PROJECT: New Two Family/Office Building

Ref. No.: 1613

PROJECT DESCRIPTION - PROPOSED REVISION TO APPROVED SITE PLAN

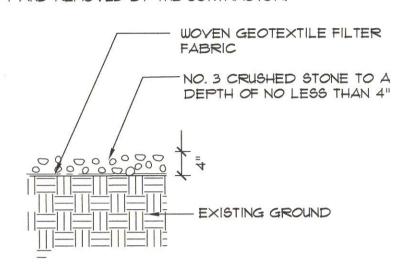
At this time, we respectfully request the Board to consider minor changes to the approved Site Plan for the project mentioned above. The changes are as follows and are shown on the attached SP-1 drawing:

- Rotate parking to enter the site straight in from St. George Place.
- Reduce overall parking area; approved was 2.0' from the west property line and the proposed is 20.8'.
- Reduce overall impervious parking surface area by approximately 27%, from 1,857 SF to 1,316 SF.
- Provide same approved fence at this location to provide screening to neighboring property.
- Reduce the approved curb cut from 20' to 12'.
- Provide one 12' curb cut to house/garage and one 12' curb cut to parking area.
- Four parking spots are required and four parking spots are provided.
- Locate trash bins as shown and provide both plantings and fence screening.

YARIANCES REQUIRED BASED ON REVISED DRAWINGS DATED 6/1/2017.

(9) - PROPERTY LINE SETBACK FOR PARKING - 10' IS REQ'D, HAS 10', THEREFORE VARIANCE IS ELIMINATED.

(10) - MAX. CURB-CUT REQUIRED - 12' IS REQ'D, HAS 12', THEREFORE VARIANCE IS ELIMINATED

(II) - FRONT YARD SETBACK FOR PARKING - 30' IS REQ'D, HAS II.2', THEREFORE AN 18.8' VARIANCE IS NEEDED.
